**TOWN OF NEWBURGH  
PLANNING BOARD  
TECHNICAL REVIEW COMMENTS**

**PROJECT NAME:** RIVIAN AUTOMOTIVE  
**PROJECT NO.:** 2021-35  
**PROJECT LOCATION:** SECTION 96, BLOCK 1, LOT 6.2  
**REVIEW DATE:** 30 DECEMBER 2021  
**MEETING DATE:** 6 JANUARY 2021  
**PROJECT REPRESENTATIVE:** GPD ENGINEERING & ARCHITECTURE

**DCFC ADVENTURE NETWORK**  
 1219-1221 ROUTE 300  
 NEWBURGH, NY 12550  
**CIVIL SITE PLAN**

PROJECT MANAGER	DESIGNER
IM	KSB
JOB NO. <b>2020264.38</b>	
<b>C-111</b>

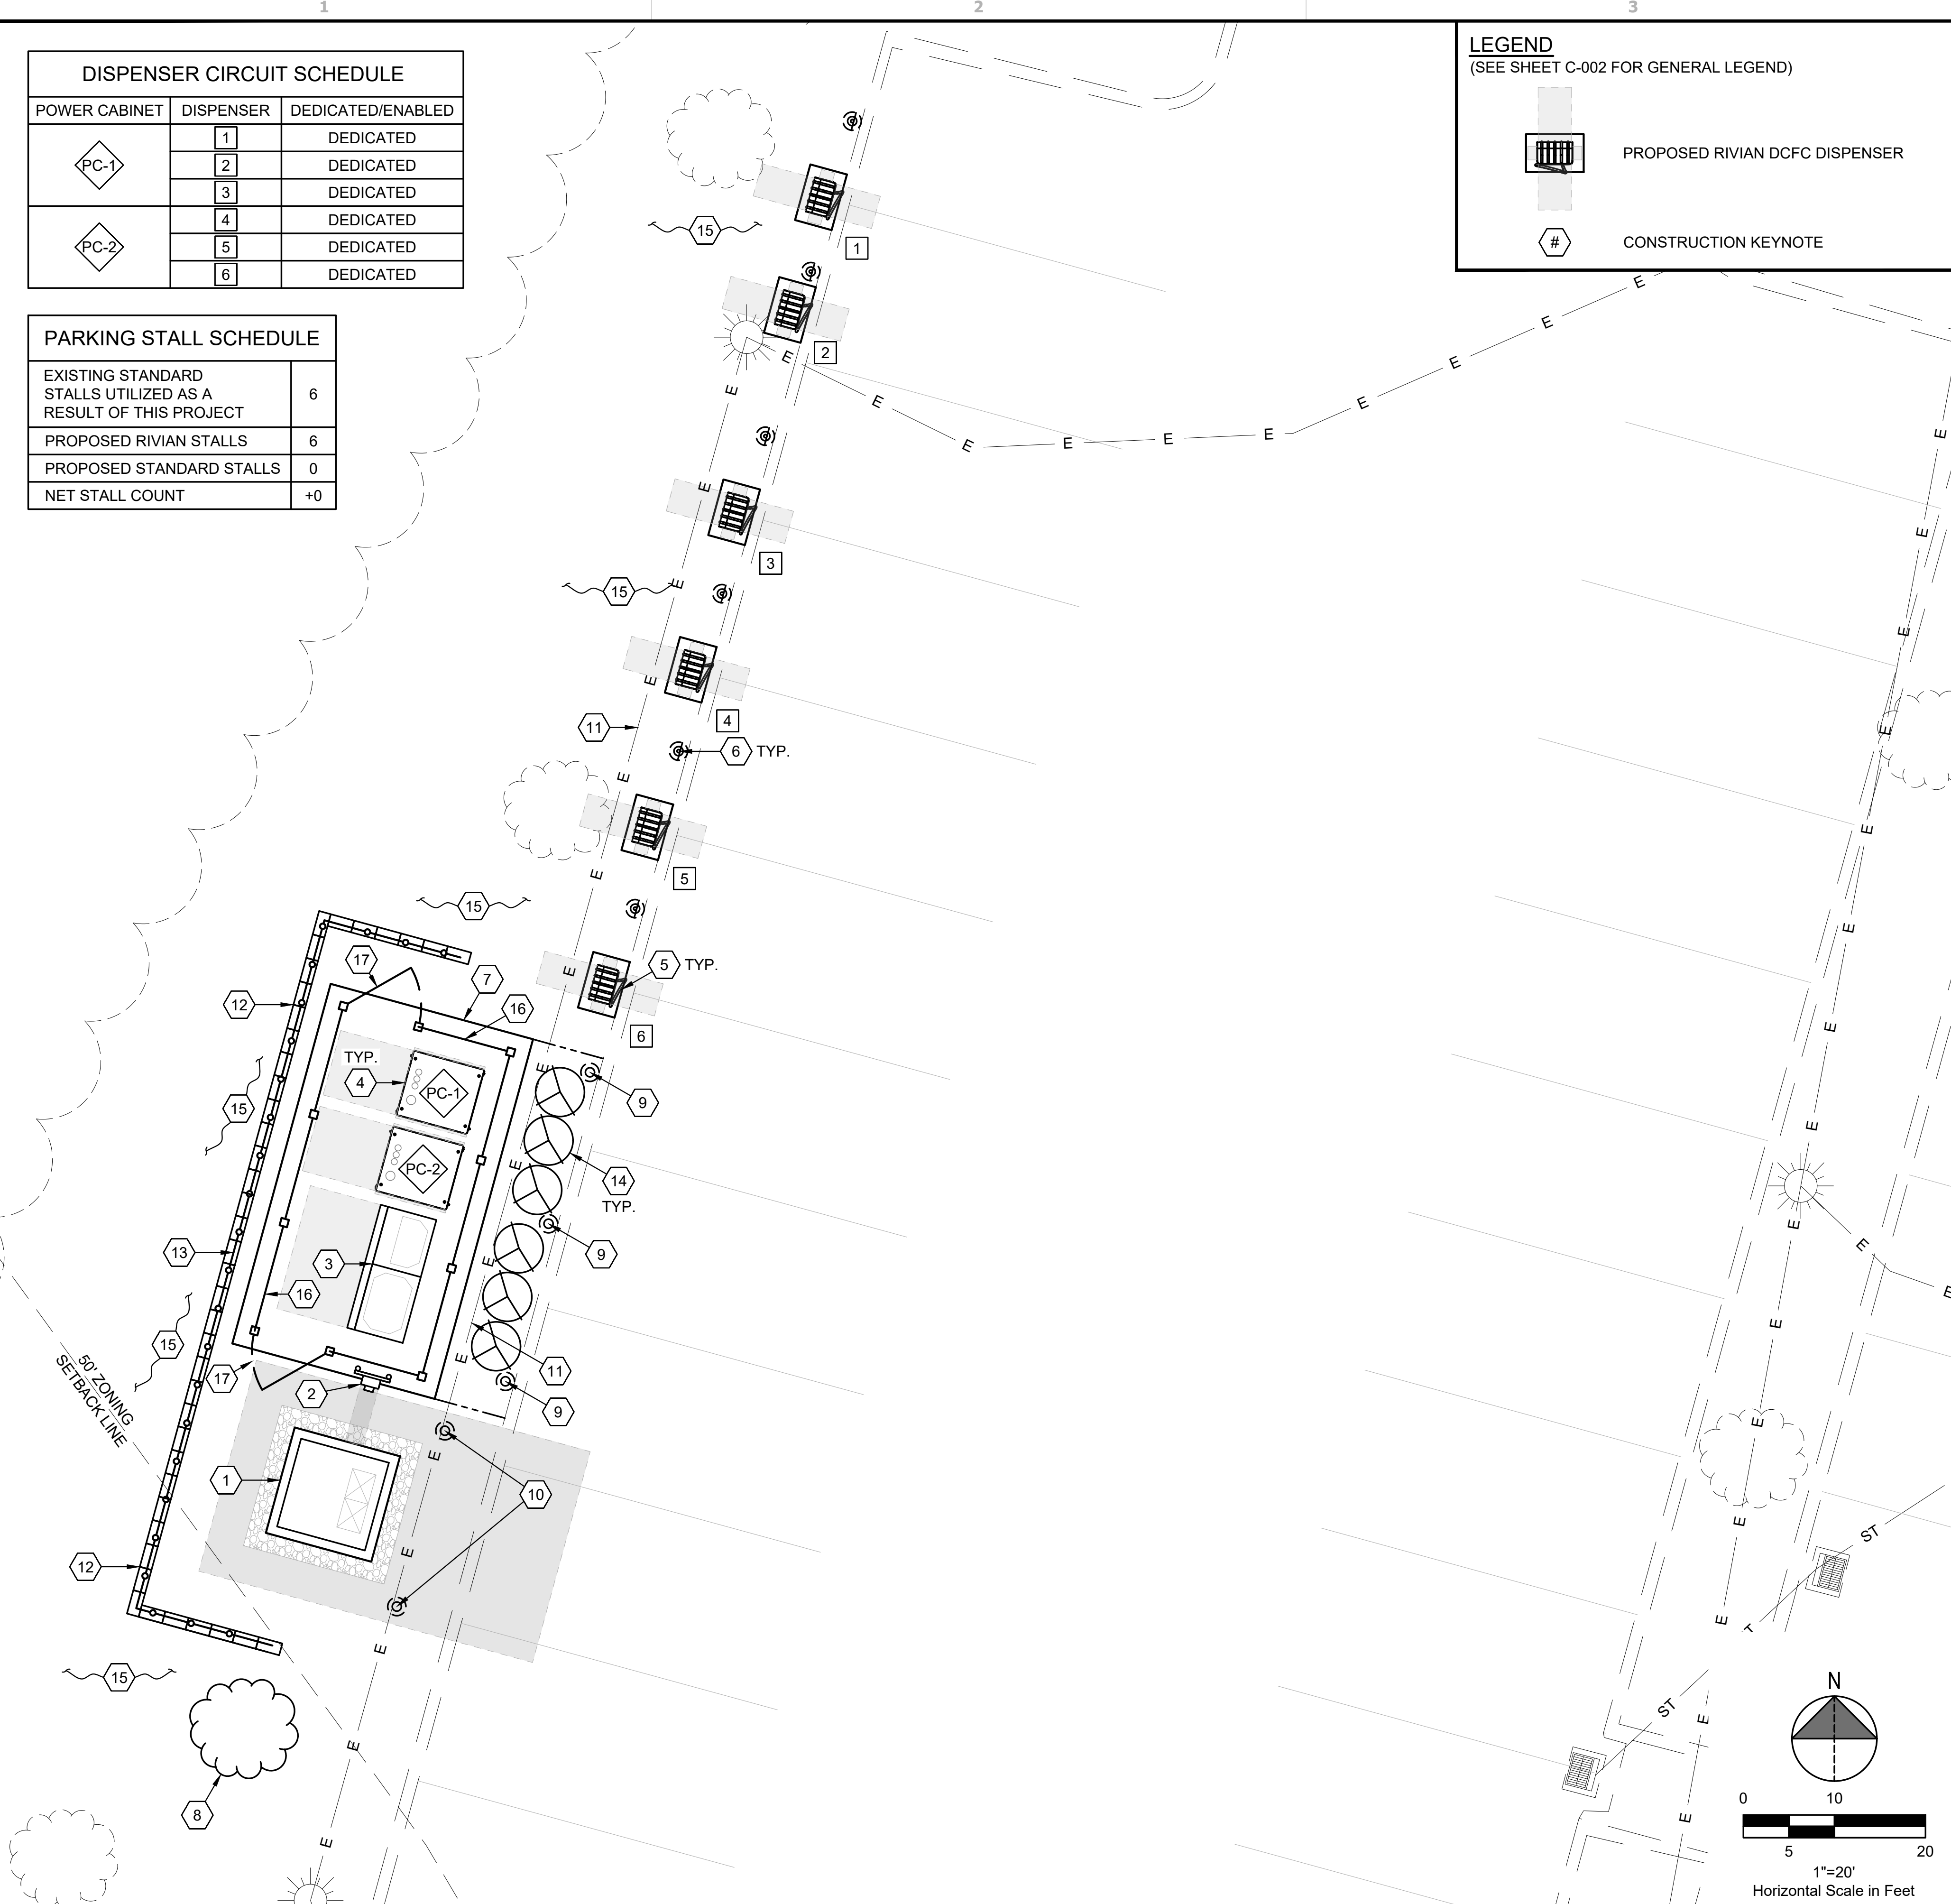
2. The parking analysis should be submitted identifying that sufficient non-electric vehicle charging areas are available based on the use of the site as a shopping center. Currently the site contains designated Tesla charging stations. This application proposes 6 parking spaces designated for electric vehicle charging.

TYPICAL WALL SECTION N.T.S 1

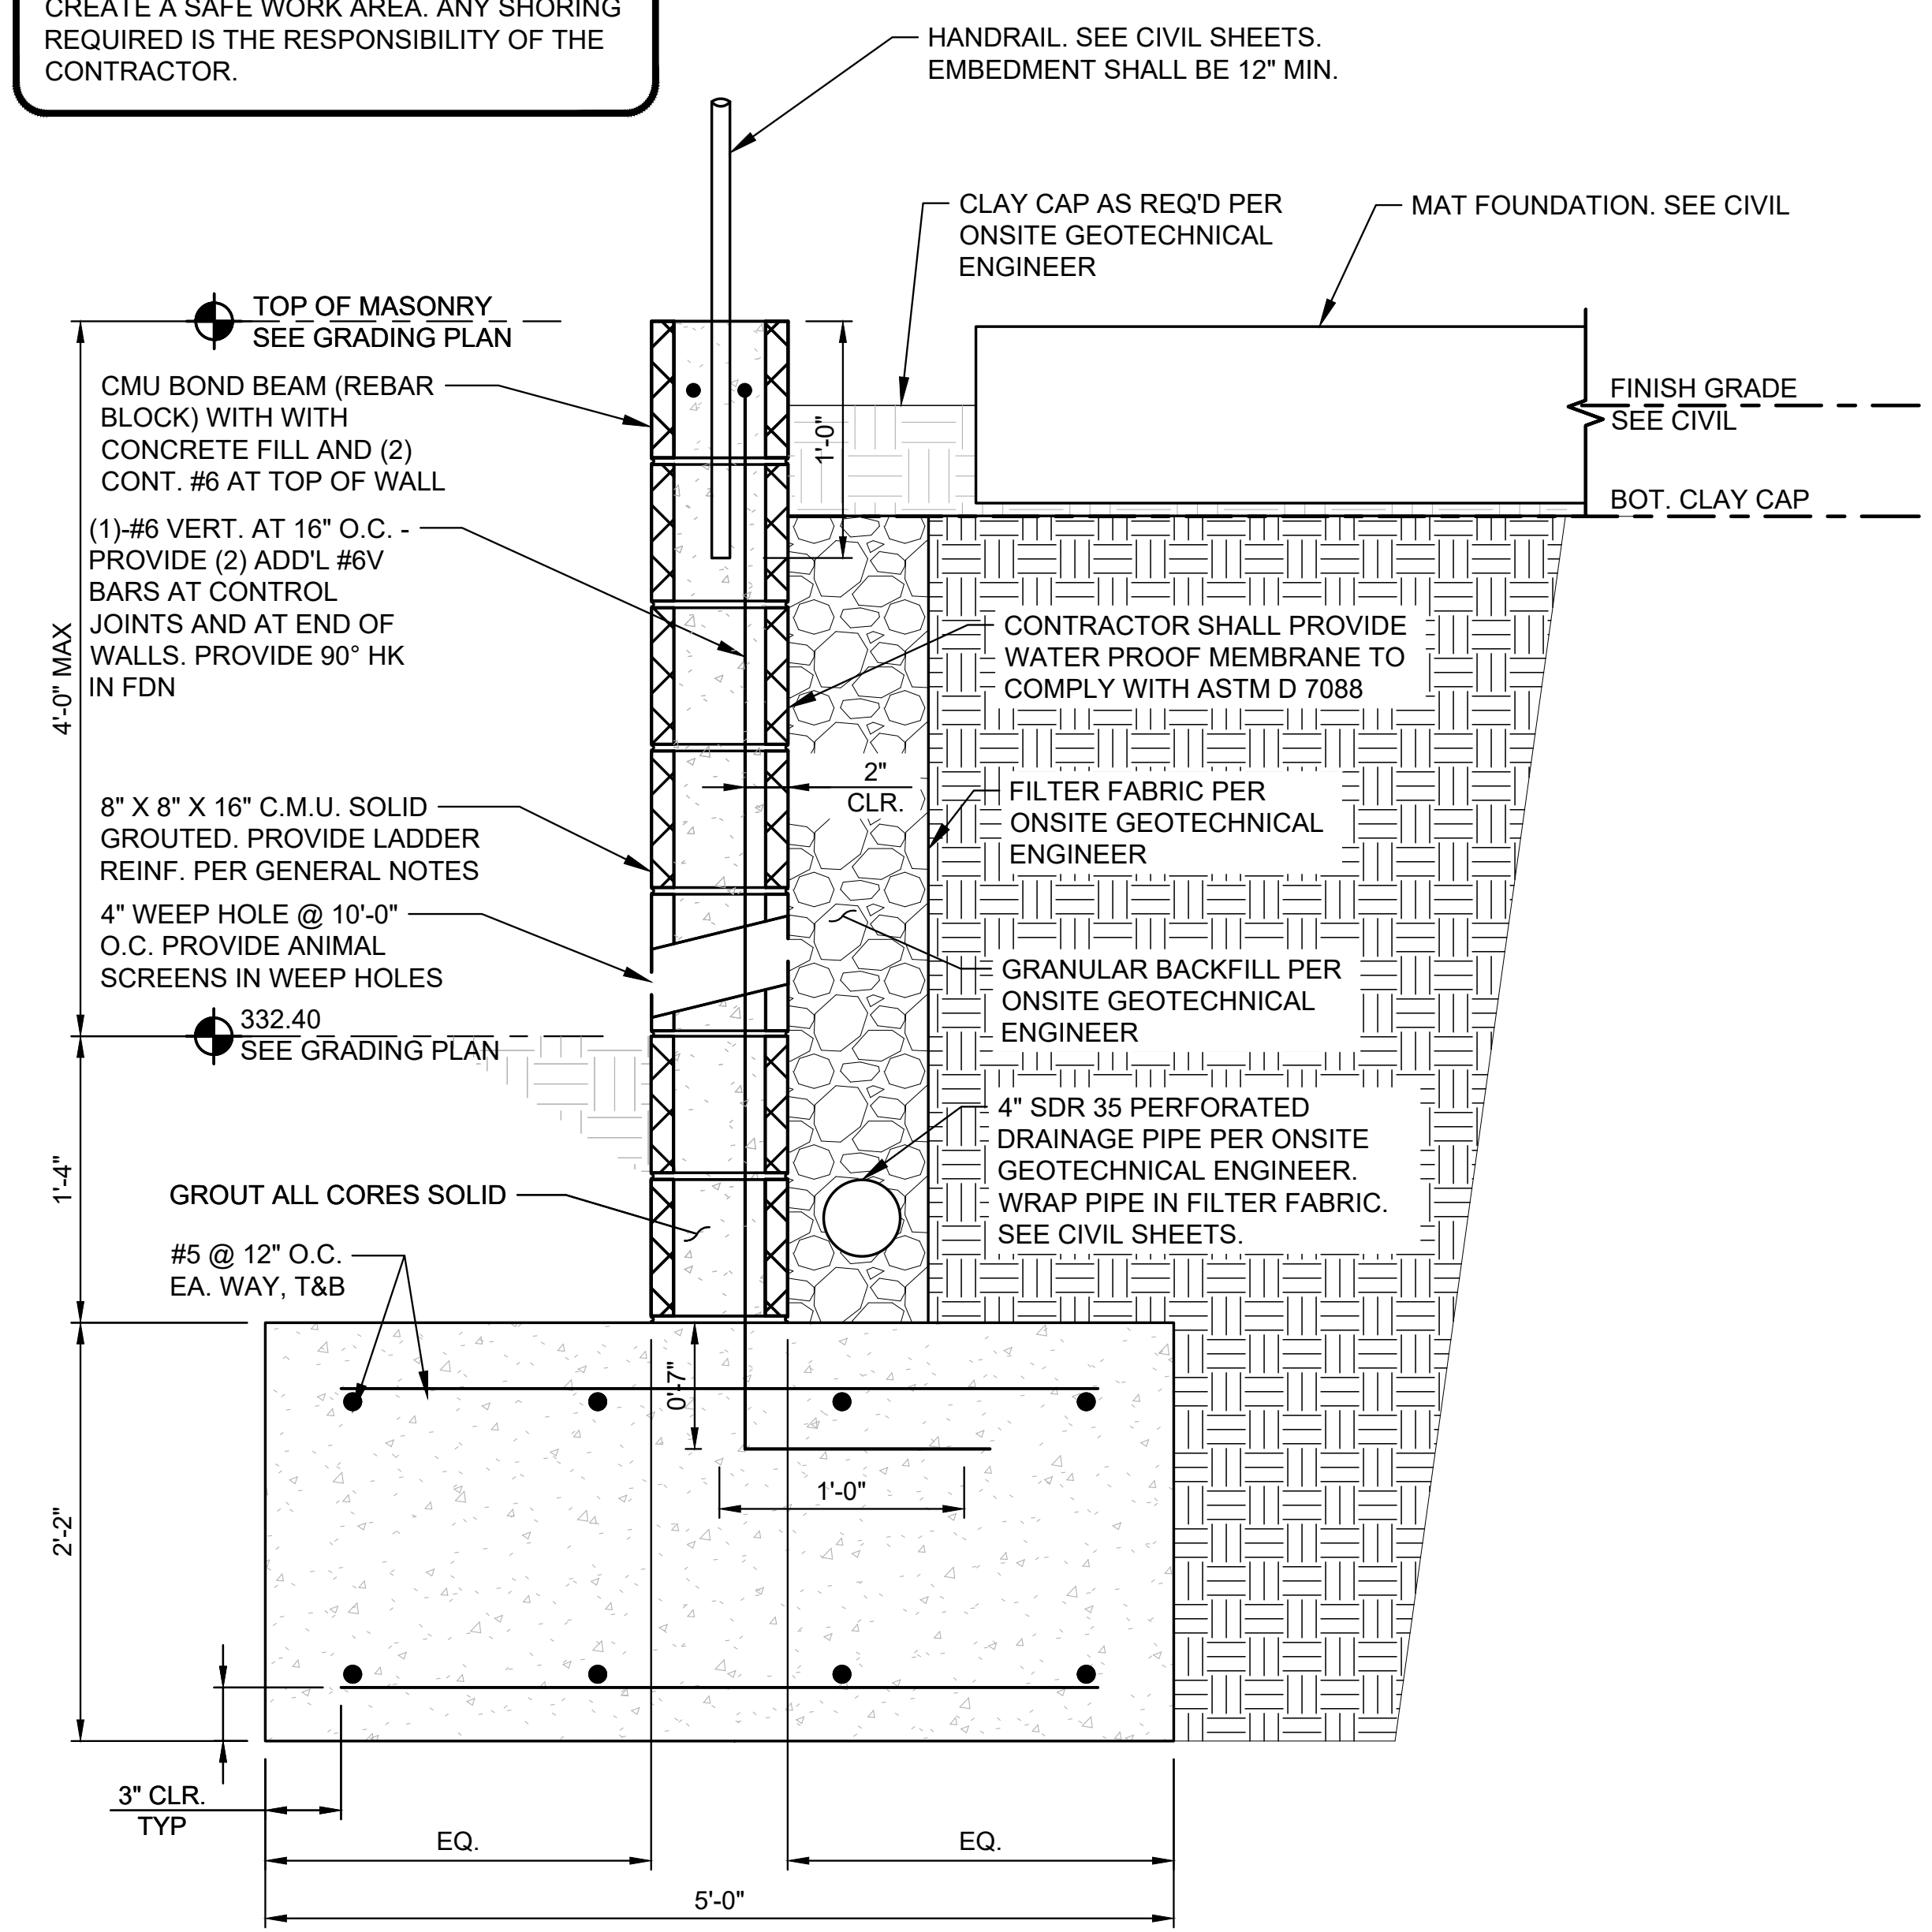
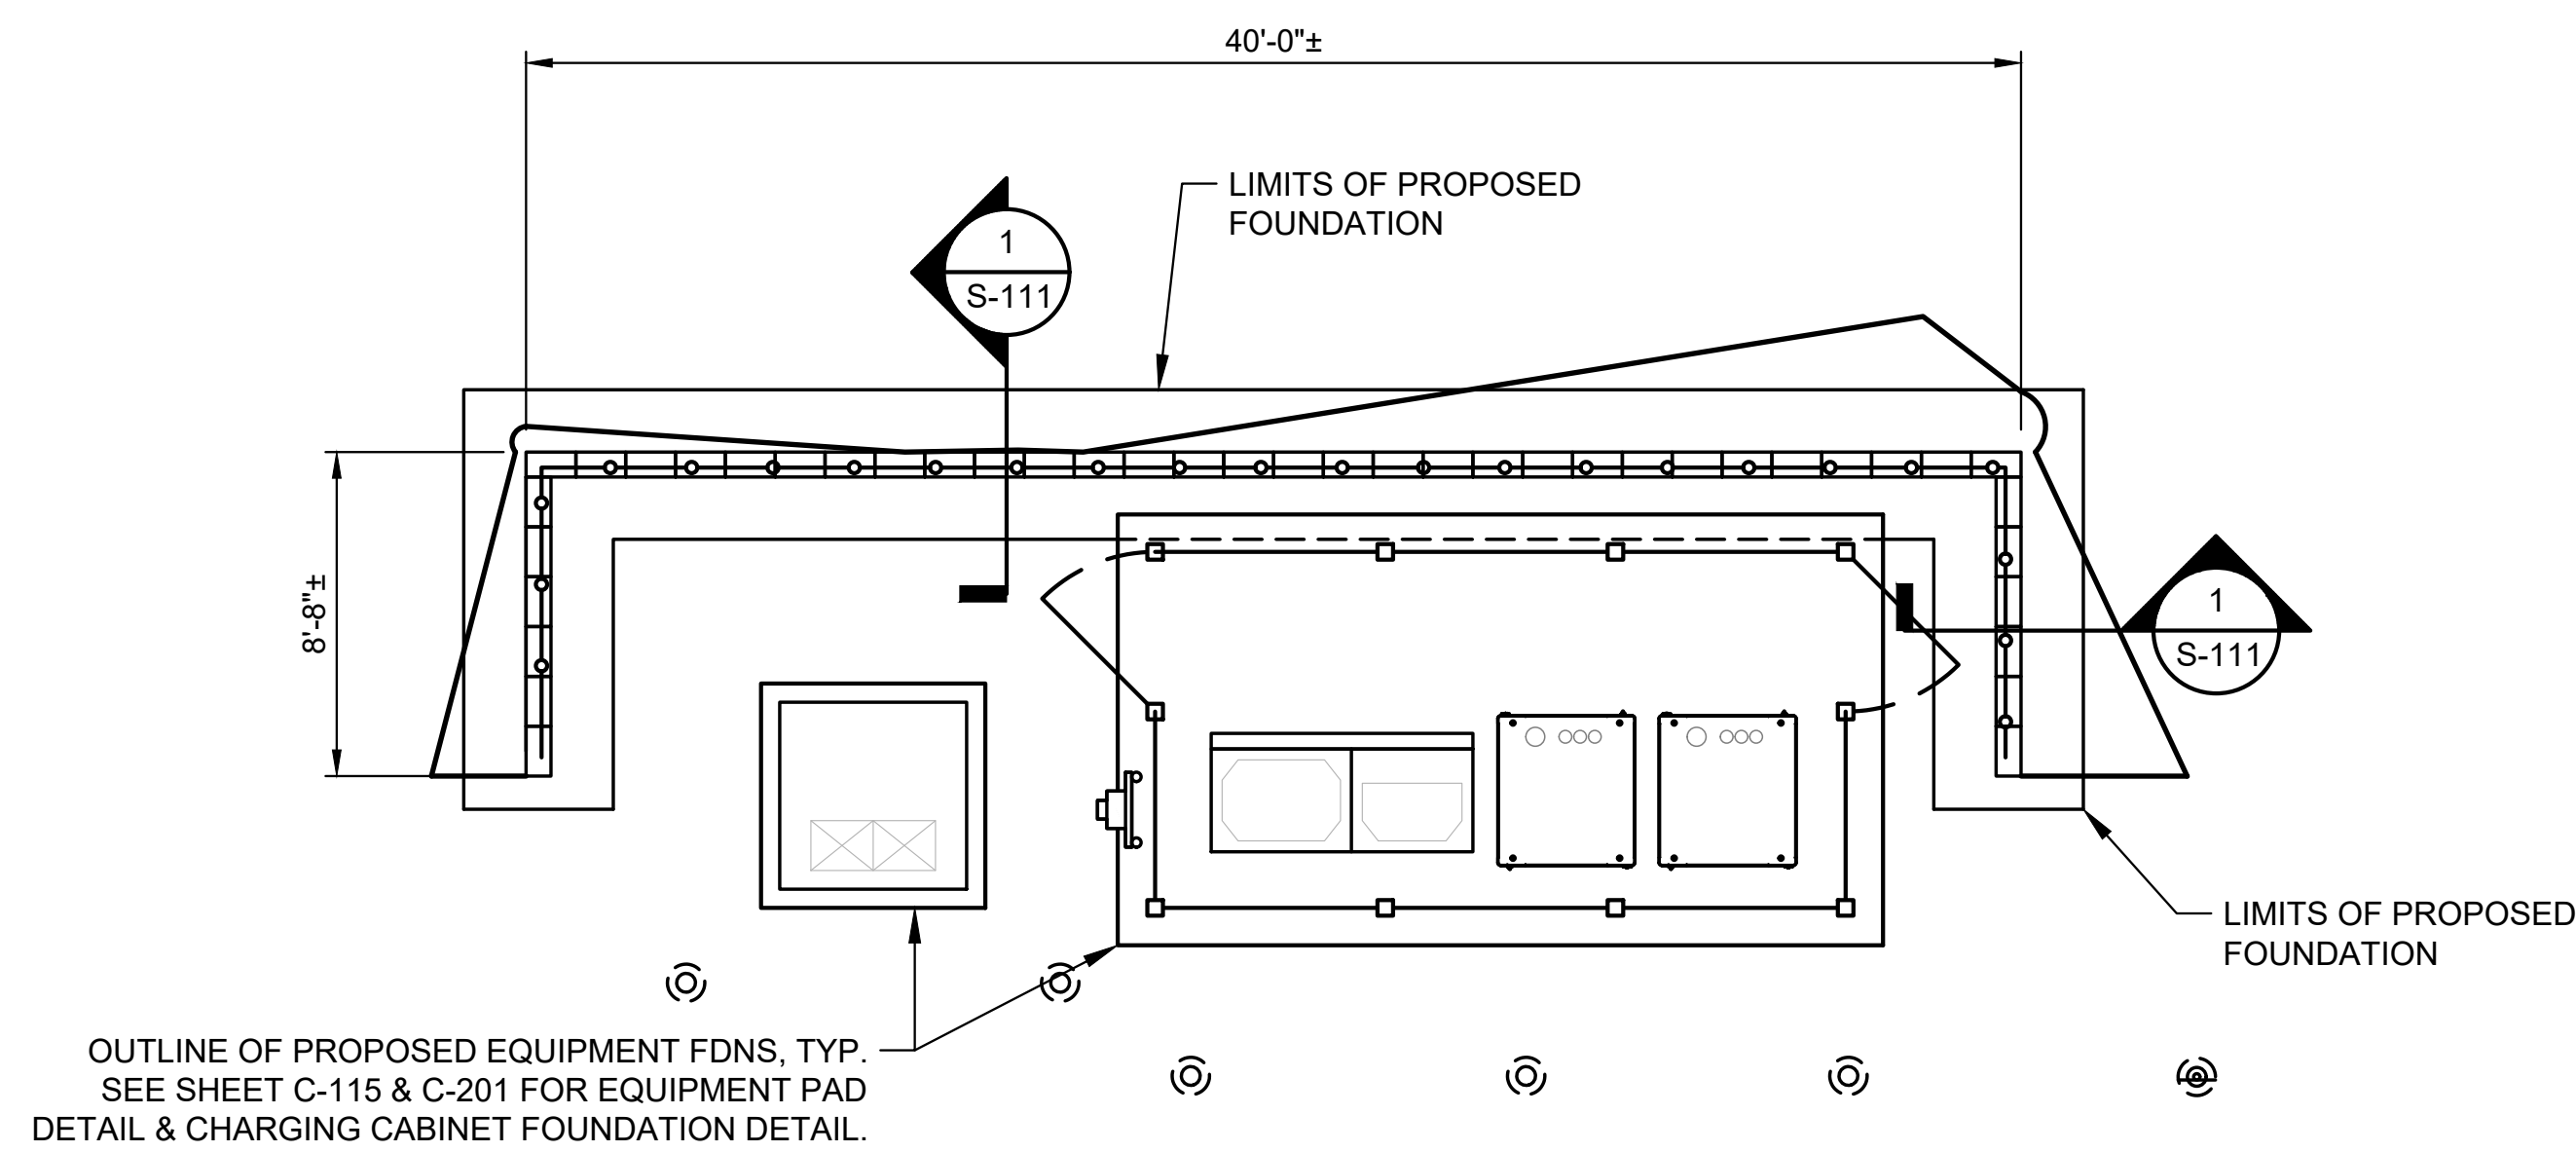
5. The applicant is requested to identify if the type of CMU block utilized for the lower retaining wall. Will split faced or other architectural covered block be utilized to match existing Site Plan.
